HISTORIC AND DESIGN REVIEW COMMISSION

HDRC CASE NO: 2019-283
ADDRESS: 138 S JOSEPHINE TOBIN
LEGAL DESCRIPTION: NCB 2027 BLK LOT A1
ZONING: R-6,H
CITY COUNCIL DIST.: 1
DISTRICT: Woodlawn Lake and Park Historic District
APPLICANT: Melissa Douglas/Douglas Architects, Inc.
OWNER: Cathleen Crabb/CITY OF SAN ANTONIO
TYPE OF WORK: Final approval the new construction of a community center
APPLICATION RECEIVED: October 18, 2019
60-DAY REVIEW: December 17, 2019
CASE MANAGER: Stephanie Phillips
REQUEST:

COSA Woodlawn Lake Recreation Center

APPLICATION FOR FINAL APPROVAL

Interpretive Element Paying Tribute to Berta Almaguer

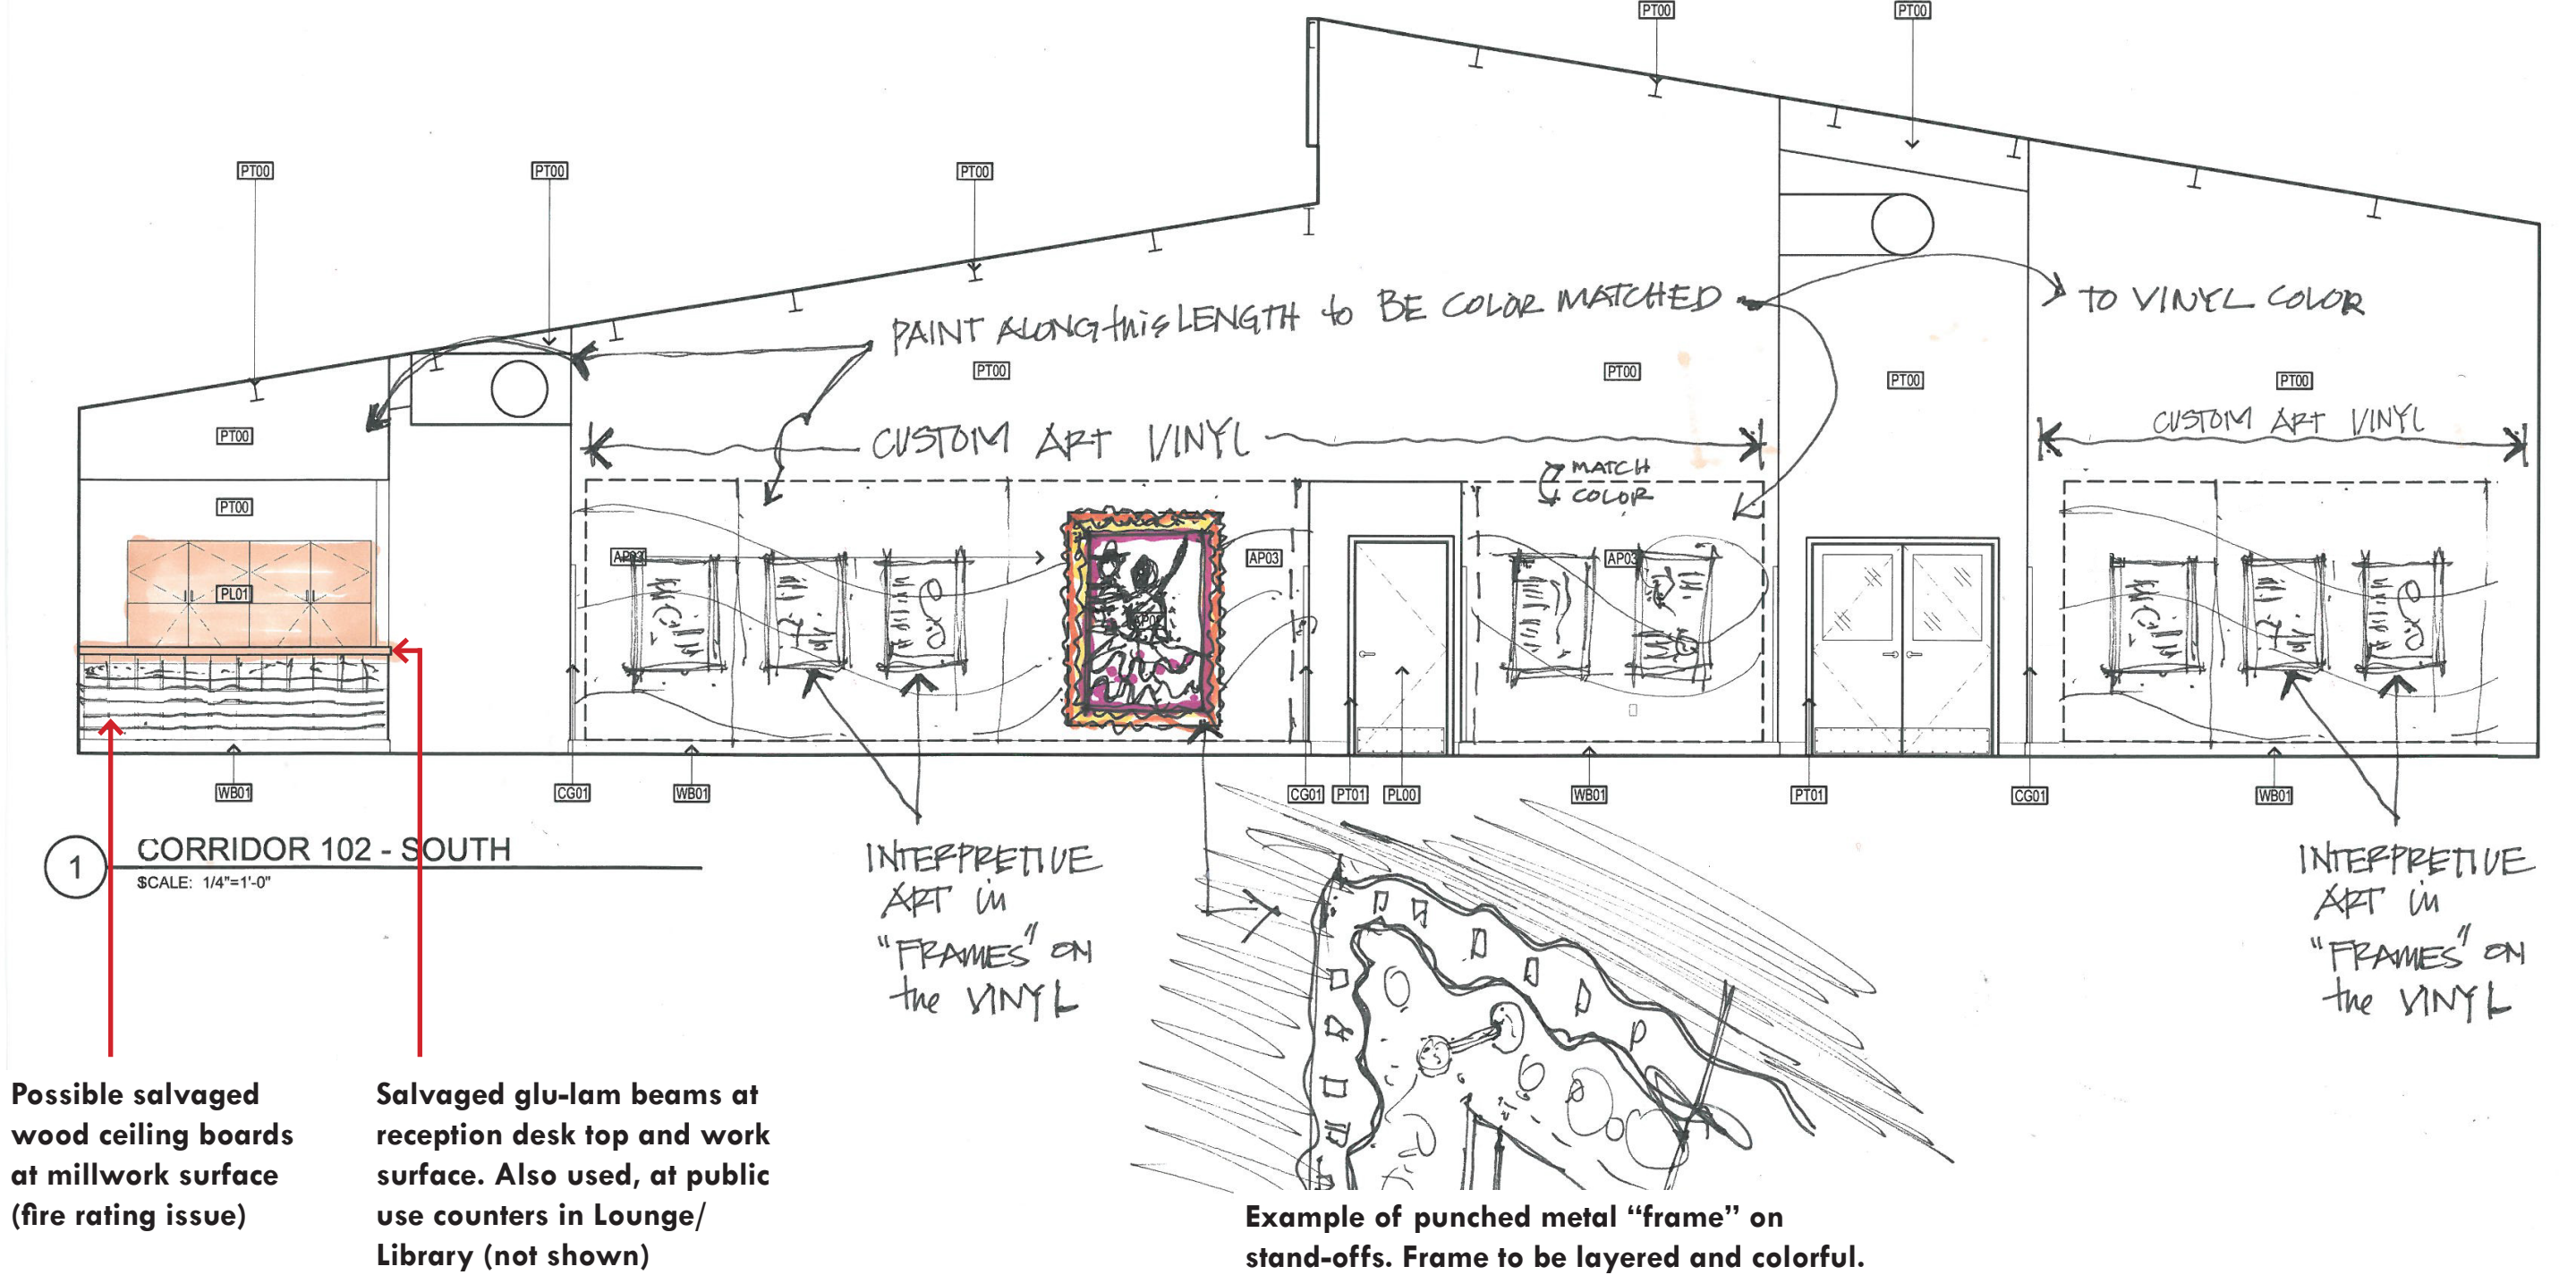
3. That the design includes an interpretative element. A gallery of images and video paying tribute to Berta Almaguer should be incorporated in the lobby (or other highly visible and sizeable area approved by HDRC). The gallery should include interpretative text describing Ms. Almaguer's contributions to the cultural heritage of San Antonio using research and materials existing in archives of the City of San Antonio Parks and Recreation Department; **this stipulation will carry over to final approval.**

- j. INTERPRETIVE ELEMENT – The existing structure is significant to the cultural heritage and image of San Antonio. Per the stipulations from conceptual approval, the design must include an interpretative element. Per the applicant's submission, a gallery of images and video paying tribute to Berta Almaguer will be incorporated in the lobby and will include interpretative text describing Ms. Almaguer's contributions to the cultural heritage of San Antonio using research and materials existing in archives of the City of San Antonio Parks and Recreation Department. Staff finds the proposal consistent.
